FINAL DRAINAGE LETTER

Dutch Bros Coffee

Falcon Marketplace – Lot 11
7510 Falcon Market Place
Falcon, CO 80831

Please provide PCD
File No. PPR-21-46

DUTCH BROS. COFFEE - CO0707 - PEYTON, CO PROPOSED CONDITIONS MAP

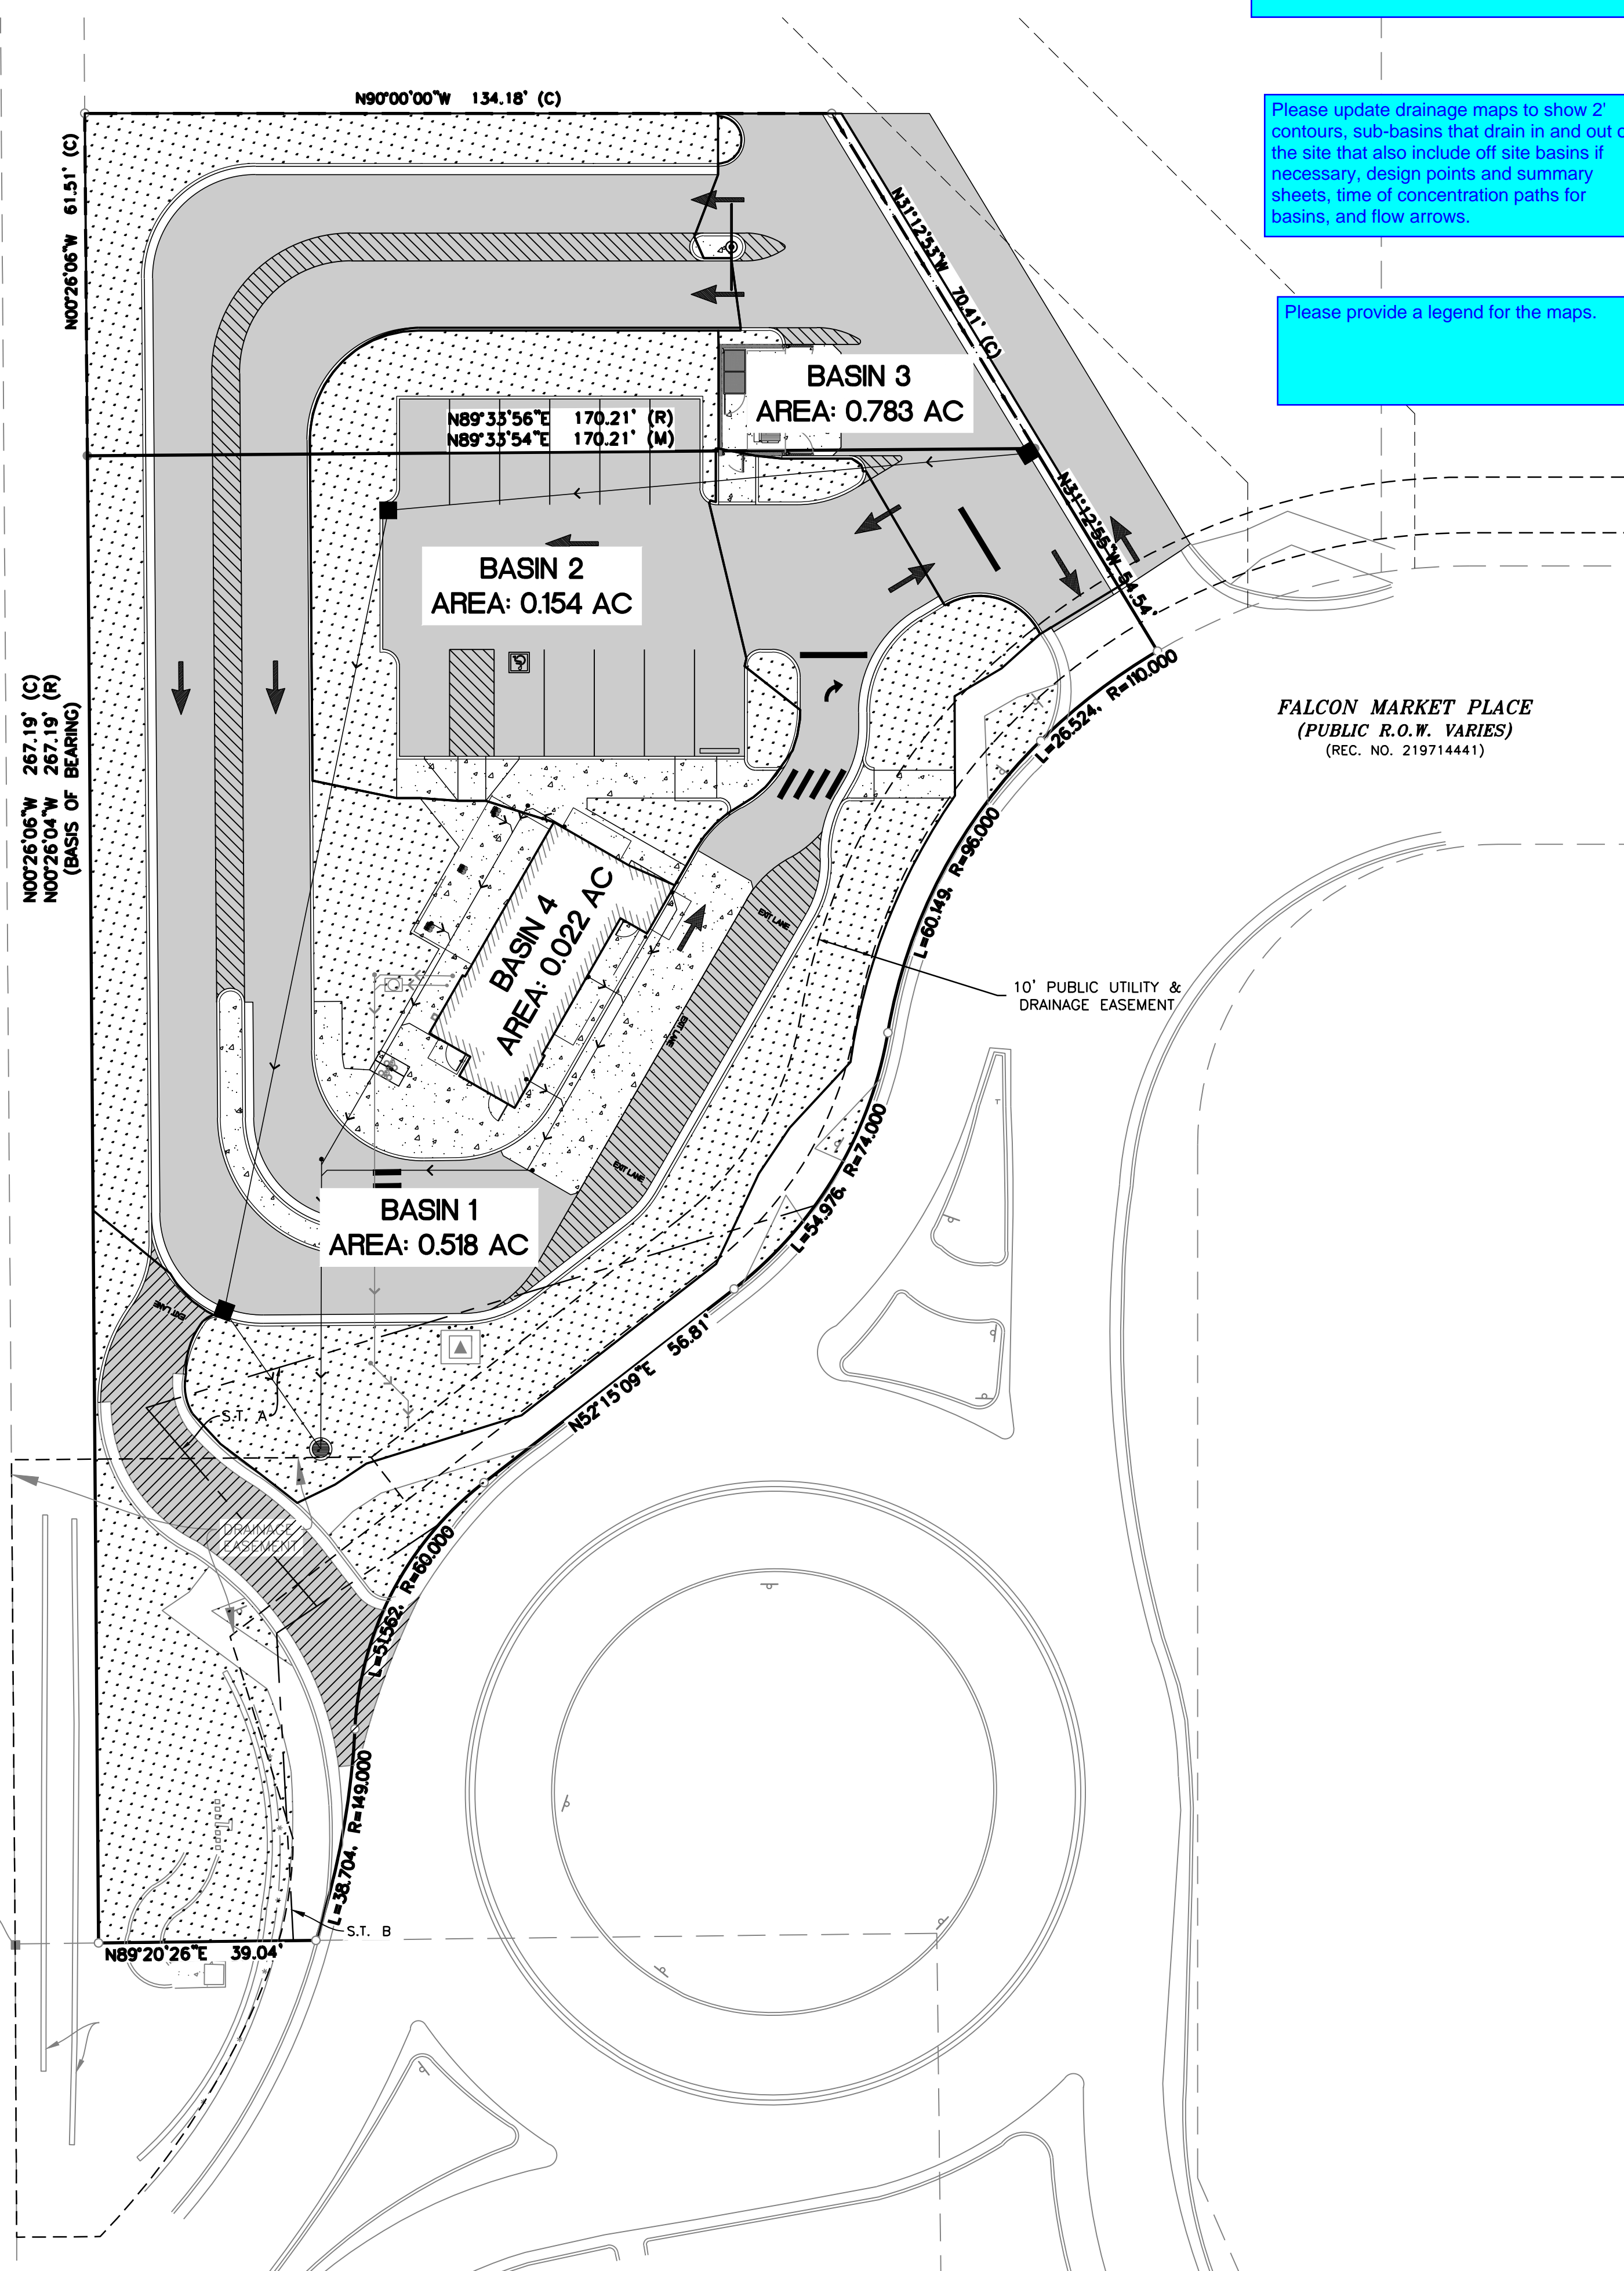
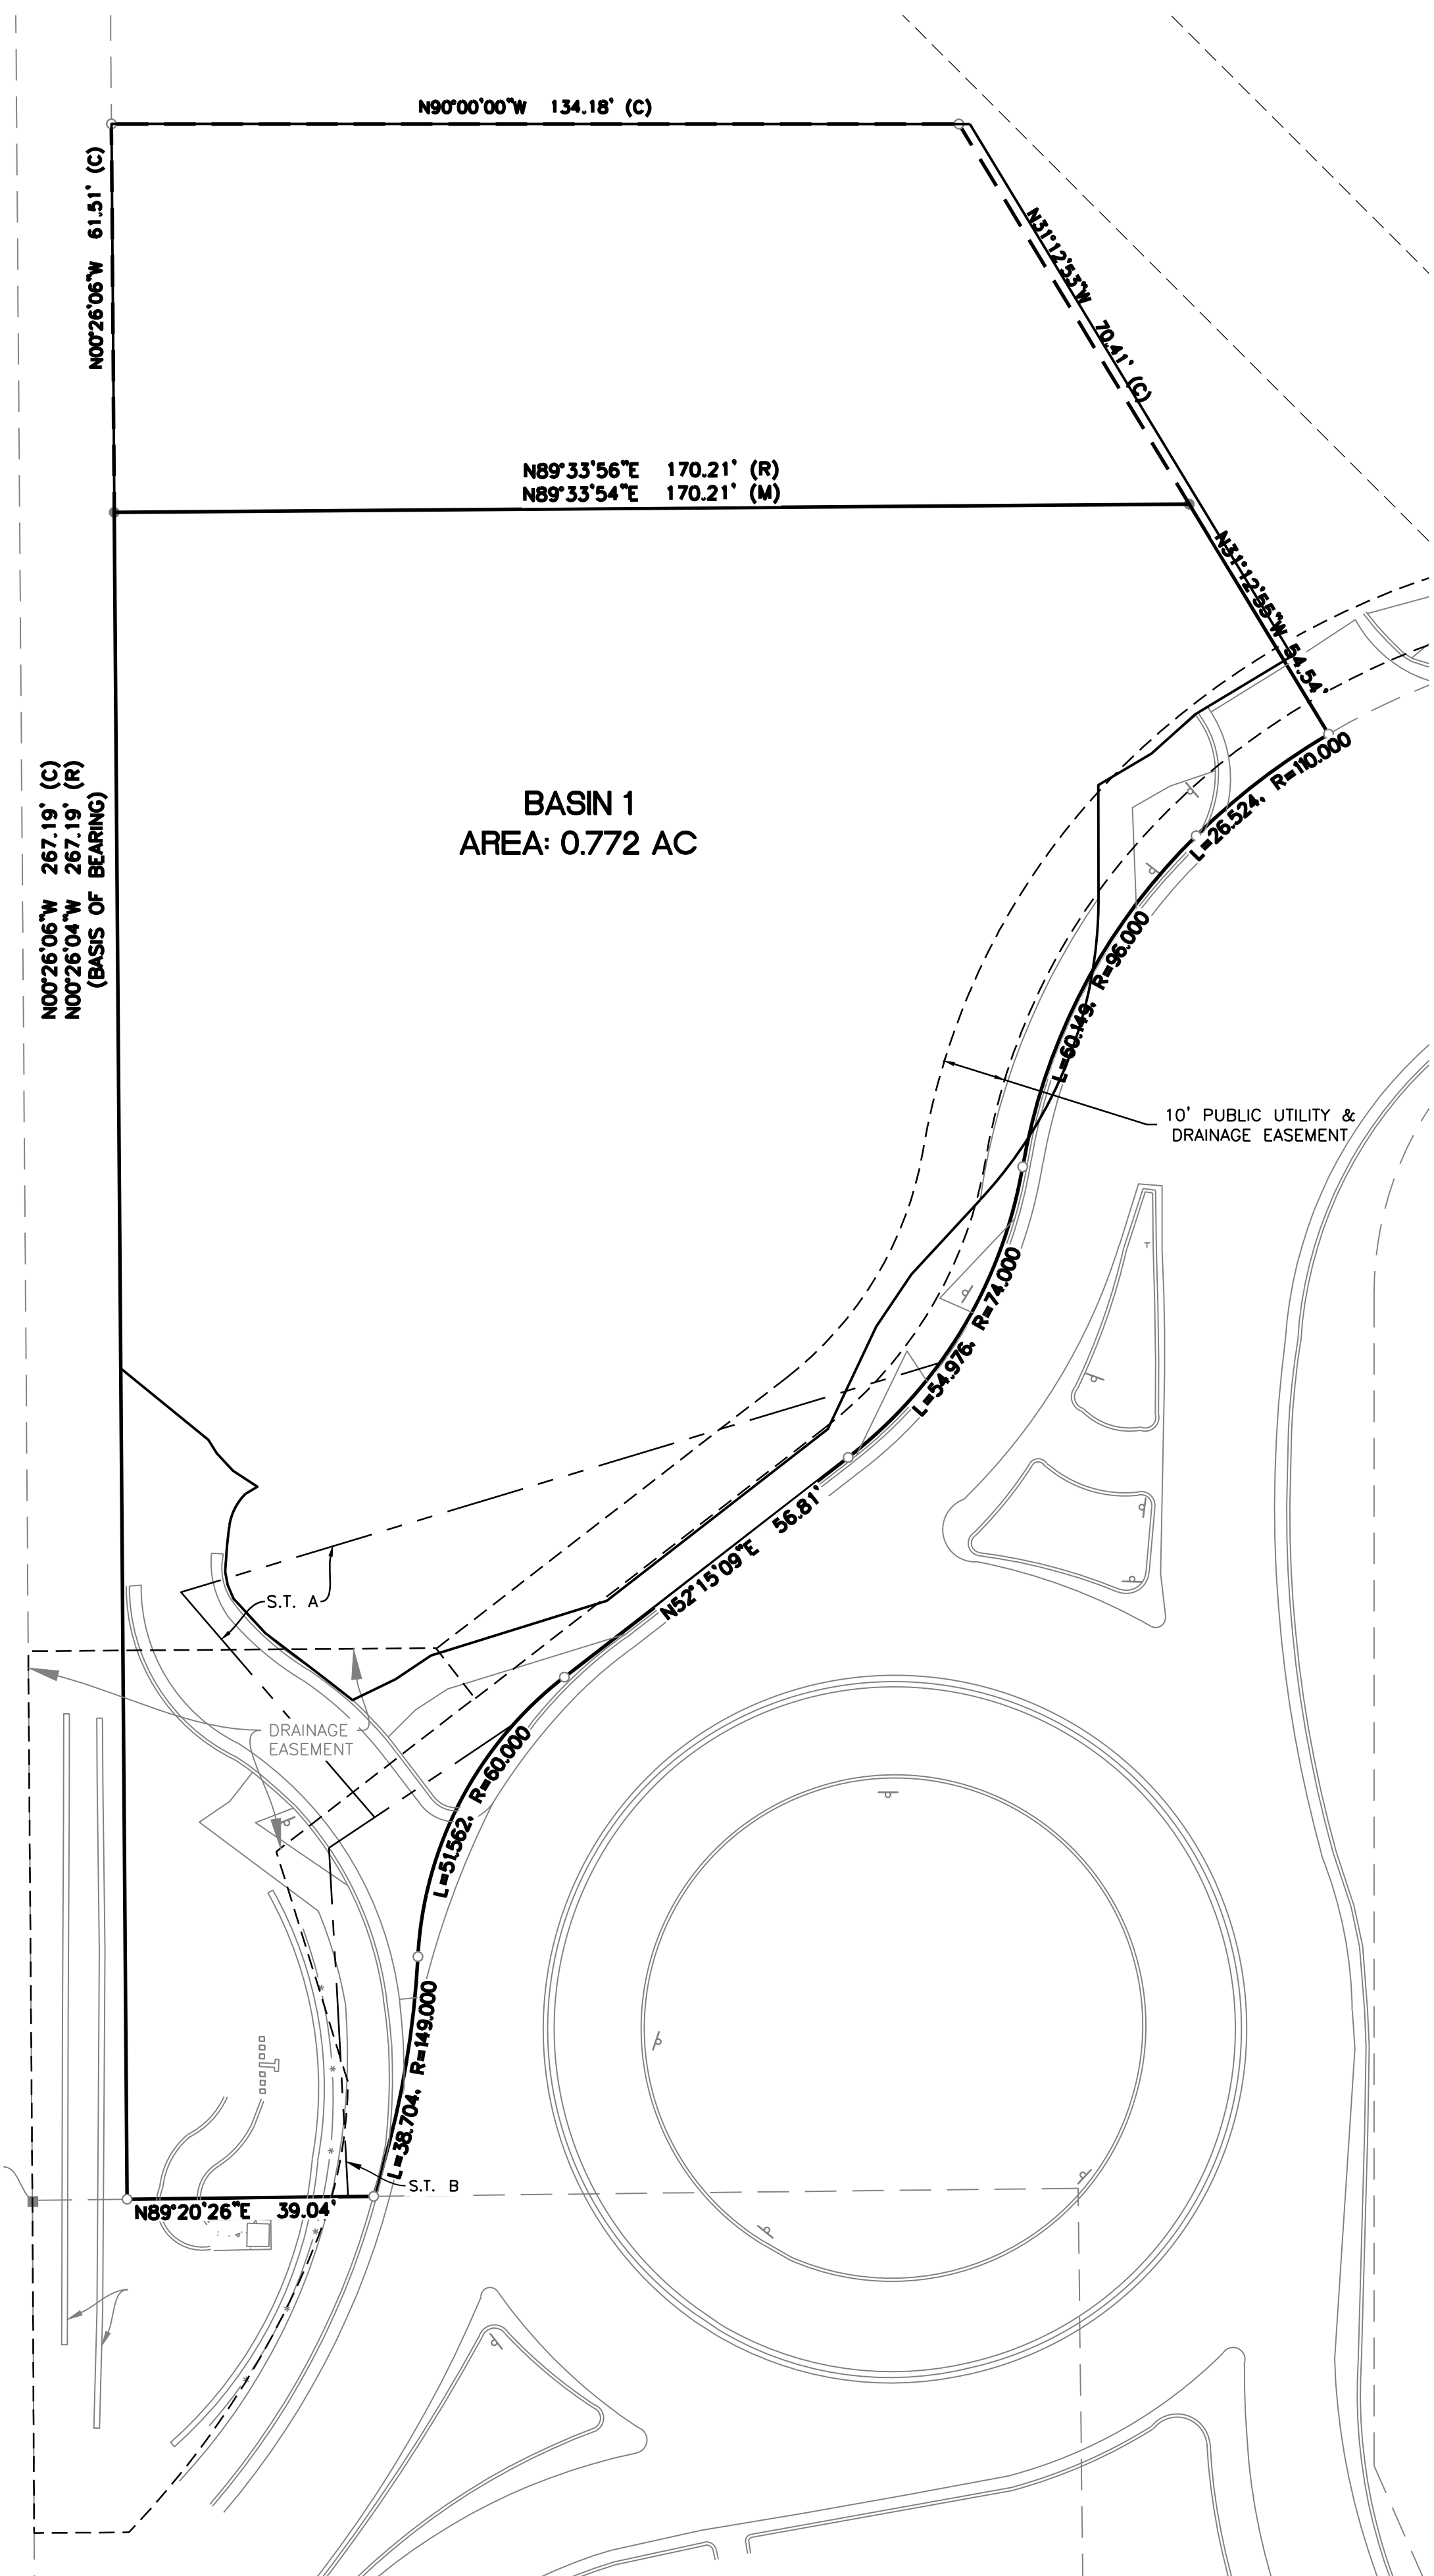
Please move drainage map to the end of the report and revise table of contents.

Please update drainage maps to show 2' contours, sub-basins that drain in and out of the site that also include off site basins if necessary, design points and summary sheets, time of concentration paths for basins, and flow arrows.

Please provide a legend for the maps.
